Re: Avista 2021 Draft Integrated Resource Plans for Electricity and Natural Gas
Dockets UE-200301 (electricity) and UG-190724 (natural gas)

The NW Energy Coalition (“NWECC” or “Coalition”) appreciates the opportunity to comment on the draft Integrated Resource Plan (“IRP”) submitted by Avista Utilities on January 4th, 2021, per the Notice of Opportunity to File Written Comments issued by the Commission on January 5th, 2021.

Figure 9.1: Lithium-ion Capital Cost Forecast

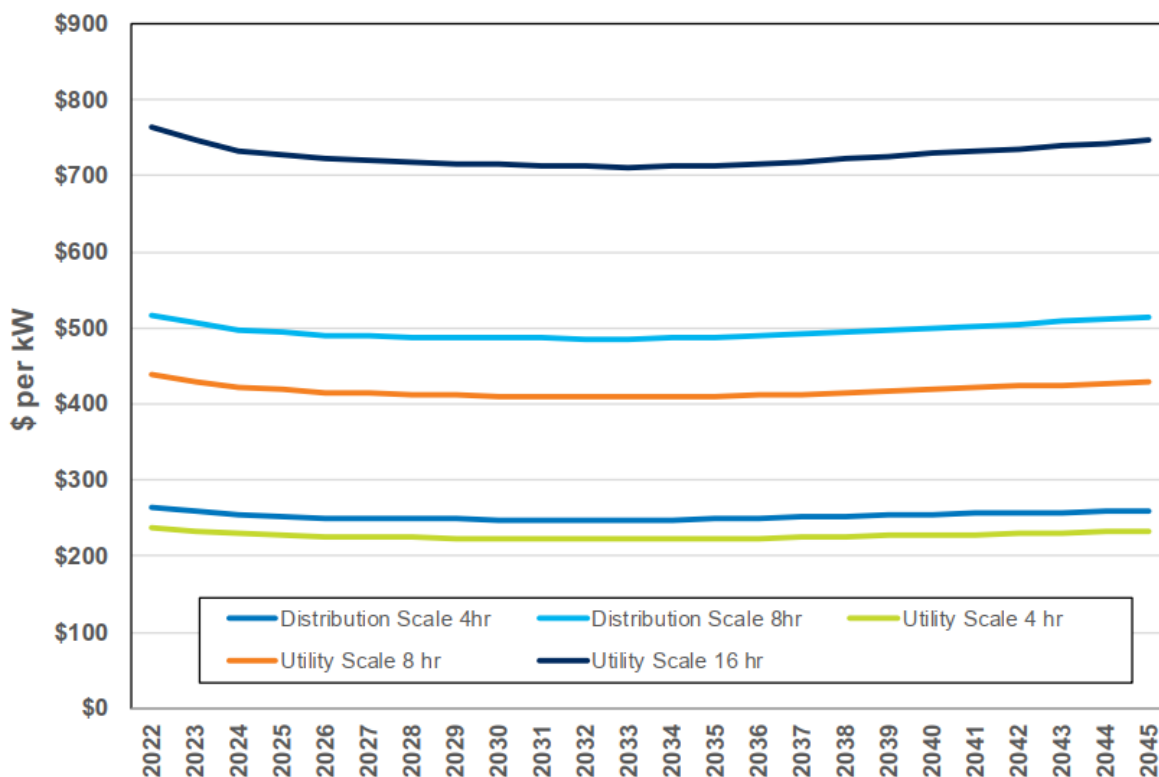
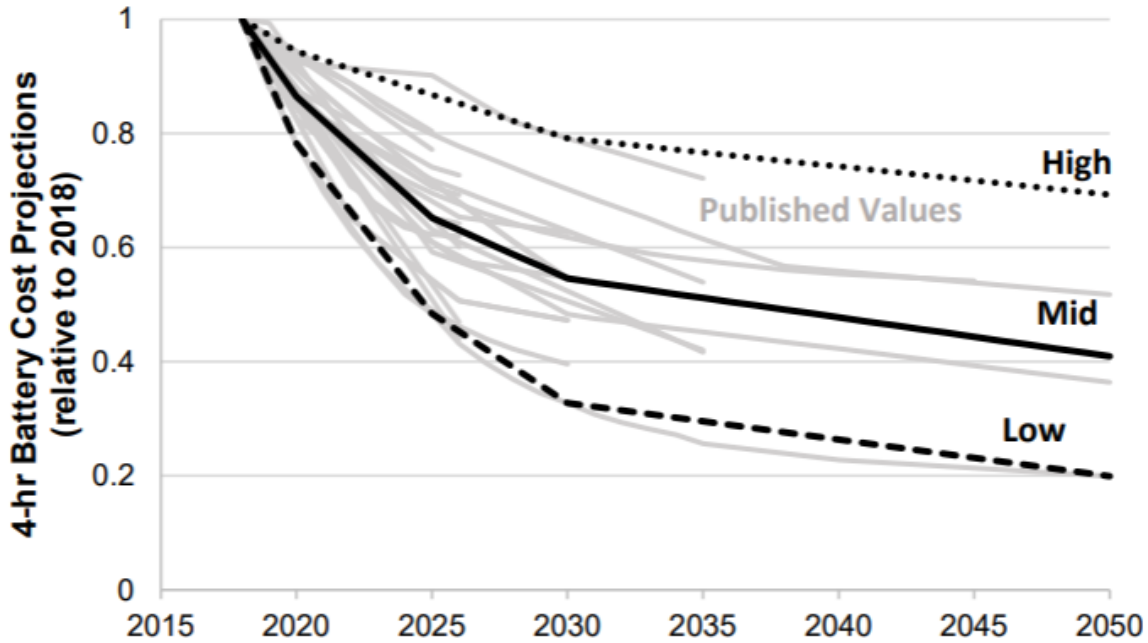
However, the future costs for batteries and pumped storage simply don't seem reasonable. The values in Figure 9.1 show slight declines in battery costs, and then flat or rising costs through the remainder of the planning horizon. Most other estimates show consistently declining costs through the coming decades, though at varying rates.
